12-19-2016

Catwalk and Tower Engineering Bulletin

New Product Now Available: Full Floor Walkway on Chief #2 and #4 Catwalk

**#2-30" Conveyor Mounting Catwalk
with Full Floor Walkway Top View**

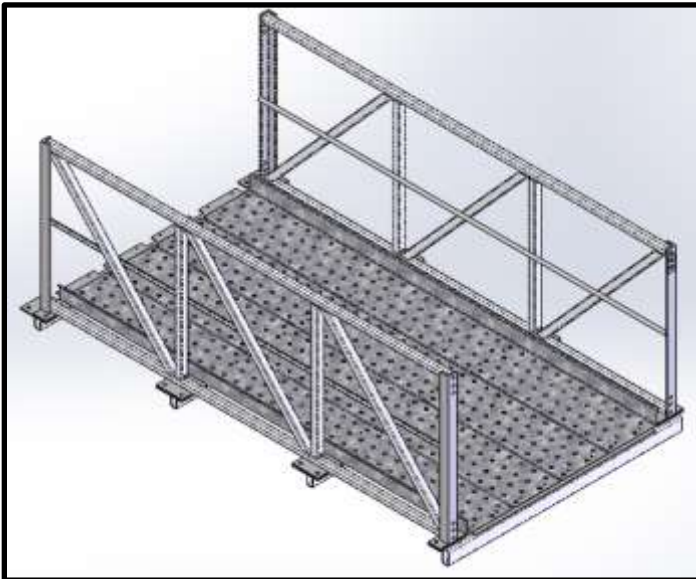
Chief Agri Industrial is pleased to announce the introduction of full floor walkway on #2 and #4 catwalks. The walkway is manufactured by Chief and has built in toe boards on each side of the catwalk. The walkway is designed to support personnel loads only and the cross members of the catwalk provide support for a conveyor. Walkway available for any width of #2 and #4 catwalk.

The walkway increases the weight of the catwalk and also increases the snow load on the catwalk. Depending on the application, the full floor walkway may reduce the maximum freespan of the catwalk. Please check with engineering prior to ordering.
